Subject: Duke Energy Carolinas, LLC
William States Lee III Nuclear Station - Docket Nos. 52-018 and 52-019
AP1000 Combined License Application for the
William States Lee III Nuclear Station Units 1 and 2
Partial Response to Request for Additional Information (RAI No. 50)
Ltr # WLG2008.12-20

Lee Nuclear Station Response to Request for Additional Information (RAI)

RAI Letter No. 025

Reference NRC RAI Number(s): 13.03-012

Transit bus routes and school location map

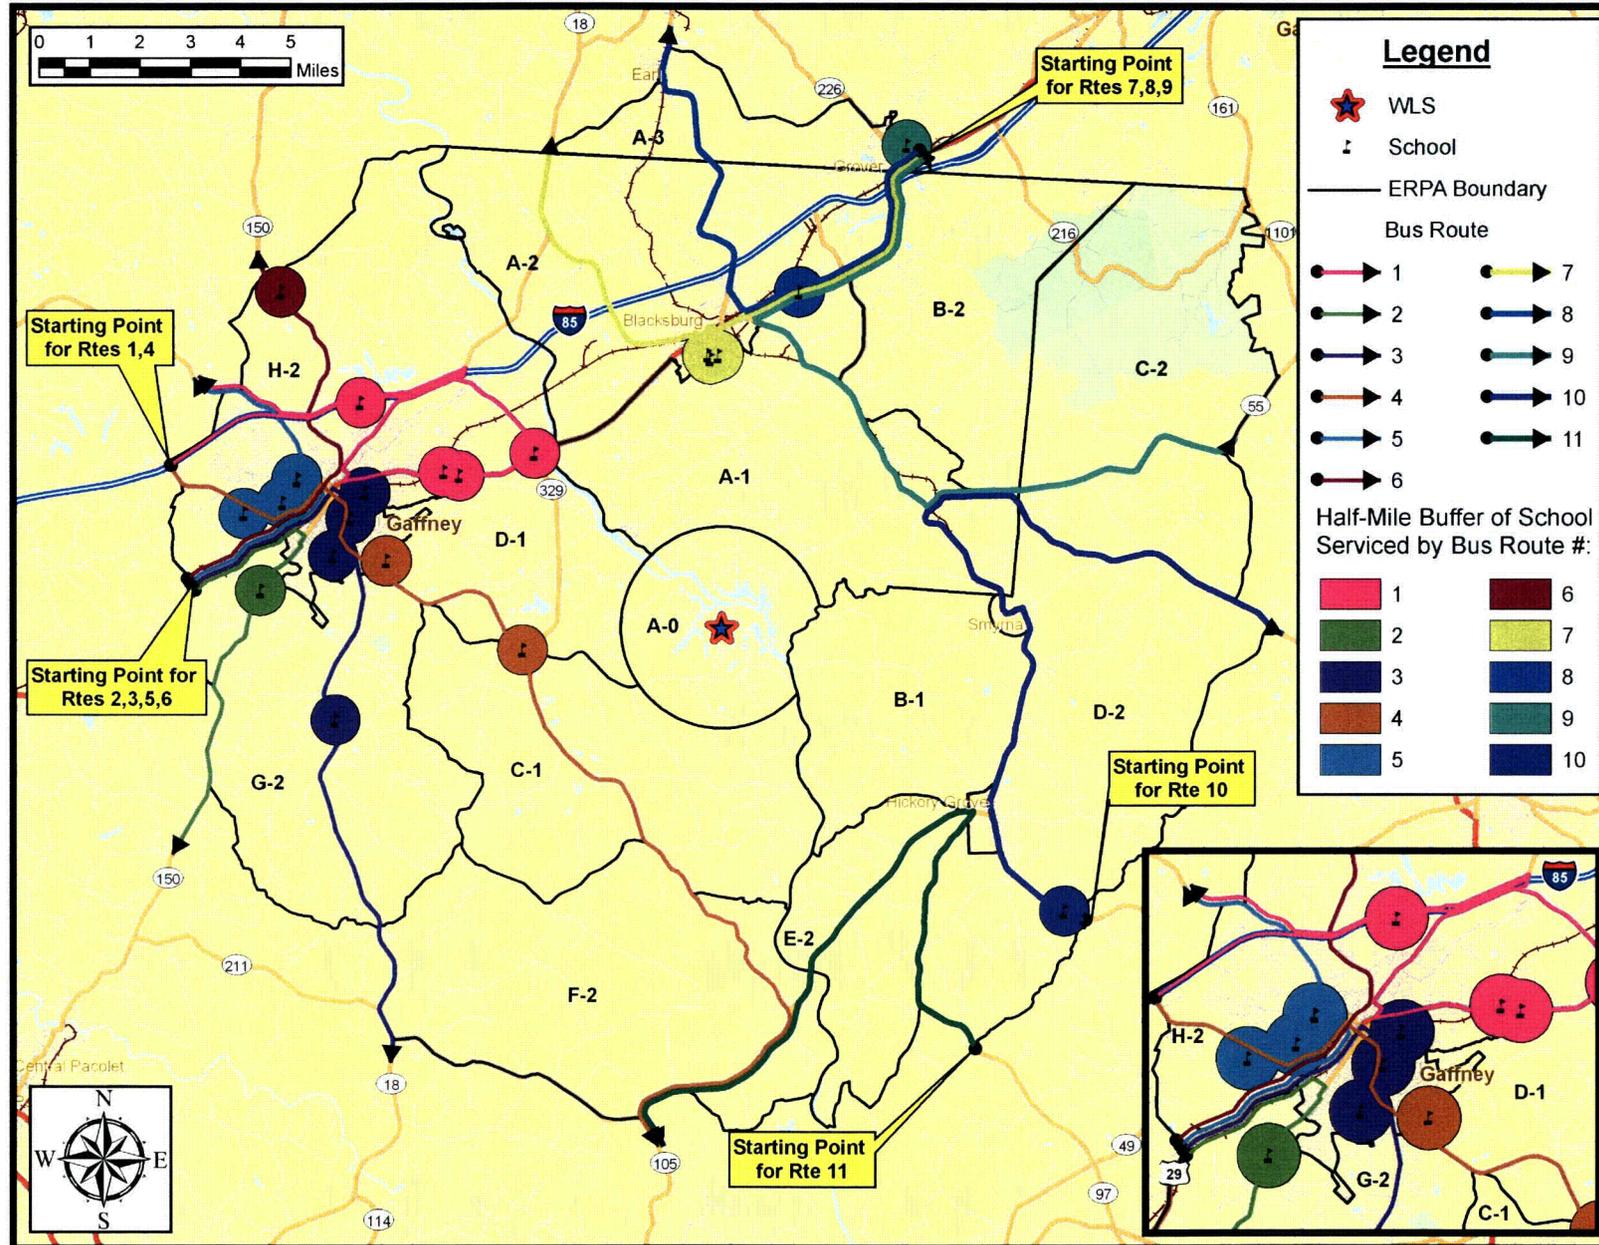
- b. If the same buses are used, explain the effect on the ETE for the transit dependent residents under this scenario.
- c. Discuss if the bus routes on Figure 8-2, "Proposed Transit Dependent Bus Routes," pass by schools to pick up residents.

- c. As discussed above, the routes were designed to service the higher population density areas in the EPZ along the major roads in the area. As the map provided as Attachment 1 shows, all of the schools in the EPZ are either located along one of these routes or are within ½ mile of the proposed transit dependent bus routes. The ½ mile buffer around each school is color coded to match the color of the bus route being served, as shown in the legend of the map. It is anticipated that some transit-dependent individuals will walk to the bus route and be picked up as the buses traverse these routes; others will walk to a school to await the arrival of a bus. Based on an assumed bus occupancy of 30 transit-dependent persons (see page 8-2 of the ETE Report), a pickup time of 30 minutes is estimated for 30 individual stops to pick up passengers, with an average of one minute of delay associated with each stop (Item f of this response provides additional information). In accordance with the Cherokee County EOP, buses will stop at the schools located near the routes to pick up transit dependent individuals that have congregated at the schools. Travel to the schools from the route will involve at most one-mile of additional travel, round trip. Assuming a speed of 20 mph, the round trip would take approximately 3 minutes to complete.

These school stops will not extend the ETE because the allowance made for picking up passengers (30 minutes) is sufficient to include the additional travel time needed to service those who have congregated at the schools. For example, assume the bus stops at a school and picks up 10 transit-dependent persons. The bus will then make a maximum of 20 more stops before reaching capacity, which would involve an estimated 20 minutes of delay. The 3 minute round trip travel time from the bus route to the school plus the 20 minutes estimated loading time for the 20 individual stops would allow 7 minutes for the bus to decelerate at the school and 10 passengers to board.

1. Revise Chapter 8 of the ETE Report to include the Transit bus routes and school location map shown in Attachment 1.
2. Revise Chapter 8, Table 8-7A and Table 8-7B of ETE Report (Rev. 1) as shown in Attachments 2, 3 and 4.
